**Project #19-029
Roderick Business Park
1137 West 1800 North**

Project Name: Roderick Business Park
Proponent / Owner: Ben Wheat / Roderick Enterprises
Project Address: Approximately 1137 West 1800 North
Request: Design Review Permit
Current Zoning: Industrial Park (IP)
Type of Action: Quasi-Judicial
Hearing Date: August 22, 2019
Submitted By: Russ Holley, Senior Planner

Staff recommends that the Planning Commission **conditionally approve** a Design Review Permit for Project #19-029, Roderick Business Park, in the Industrial Park (IP) zone located at approximately 1137 West 1800 North, TIN #04-154-0006.

FIGURE 1

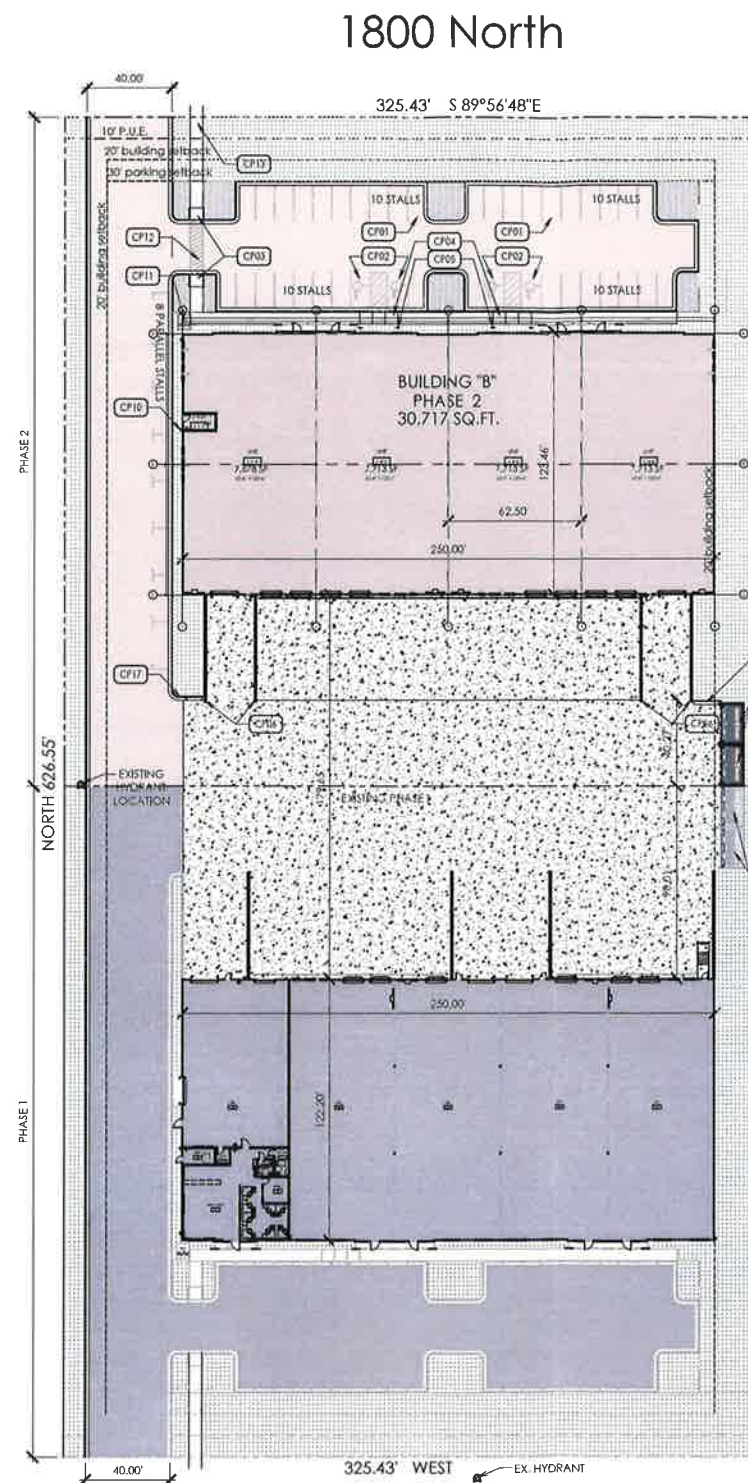
This information provides three points from which the developer's consultant can create a pressure versus flow curve to match the actual values. The actual design fire flow must be obtained from the Fire Marshall prior to completing the hydraulic analysis. Figure 1 shows the locations of this fire flow analysis.
